GXV3240/GXV3275 Firmware Release Note

FIRMWARE VERSION 1.0.3.177

GXV3240, GXV3275

07/10/2017

DNS SRV FAILOVER MODE

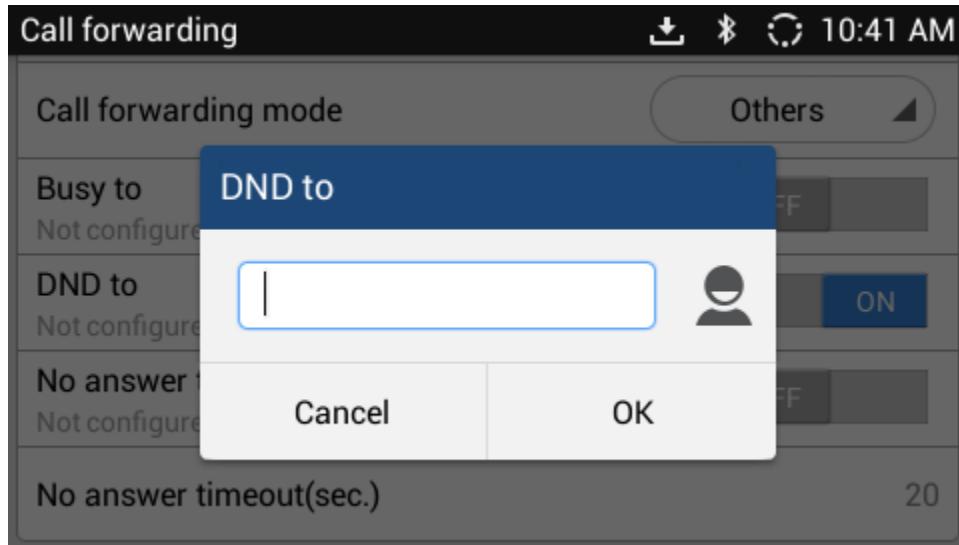
- Improved Wi-Fi module for security vulnerability concerns.
- Added web UI -> Account -> Network Settings -> DNS SRV Fail-over Mode. [DNS SRV FAILOVER MODE]

Configure the preferred IP mode for DNS SRV for each SIP account.

- If "default" is selected, first IP from query result will be applied;
- If "Saved one until DNS TTL" is selected, first IP will be applied before DNS timeout;
- If "Saved one until no response" is selected, first IP will be applied even after DNS timeout until it cannot respond.

The P-value is 26040, 26140, 26240, 26340, 26440, 26540 for Account 1/2/3/4/5/6.
